Air Gap Adaptor Fitting

Shop Drawing Submittal Review

Project Name: Webster University-**ISB**

Specification Description:	Domestic Water Specialties
	- BFP 1-4
	- Trap Primers
	- Water Hammer Arrestors

AG-4 THRU AG-8

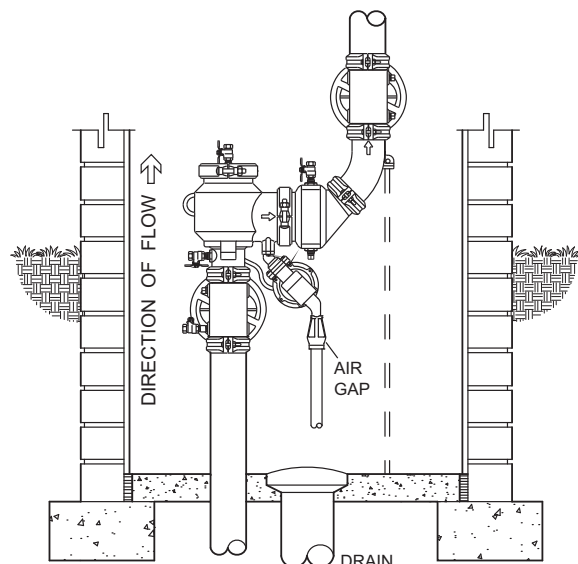
1. BFP-3 - Provide caps and tethers for each test cock.
